TECHNICAL SERVICE BULLETIN

71 C 12

October, 1971

SUBJECT: Recall Campaign A.414 Head Lamp Centres	MODELS: Triumph TR-6 All 1969, 70 & 71 Models
---	--

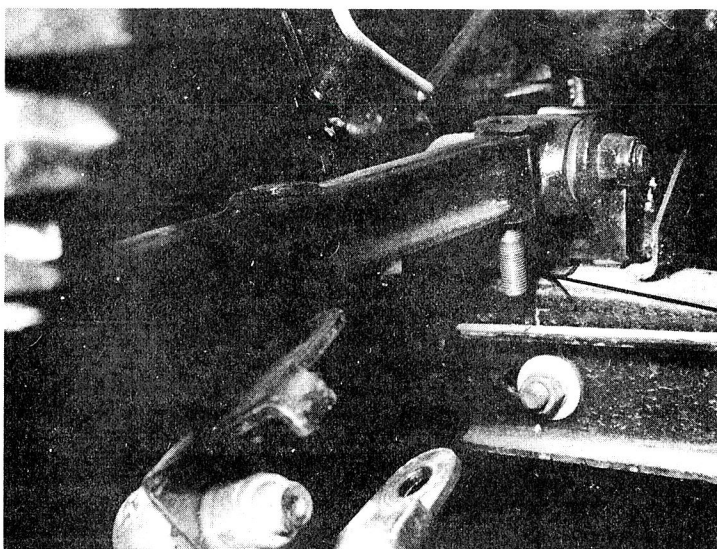
If the measurement is under 24" two of the four (1 per side) rubber packing pieces, Part #10075, top or bottom of the front coil springs must be replaced with two thicker pieces, Part #158910, as follows:-

1. Jack up front of vehicle.
2. Place jack stands under chassis member.
3. Remove wheel.
4. Remove damper.
5. Place third jack stand under hub (suitably padded).
6. Position jack with wooden block on pad under spring seat.
7. Remove spring seat securing nuts and bolts plus innermost stud on lower front suspension arm.

Remove this
Stud

8. Lower jack with spring.
9. Discard one rubber packing piece and fit one new piece, Part #158910, to either top or bottom of the spring.
10. Reassemble in reverse order.
11. Repeat on other side.
12. Align head lamps.
13. Affix label "A.414" marked as below
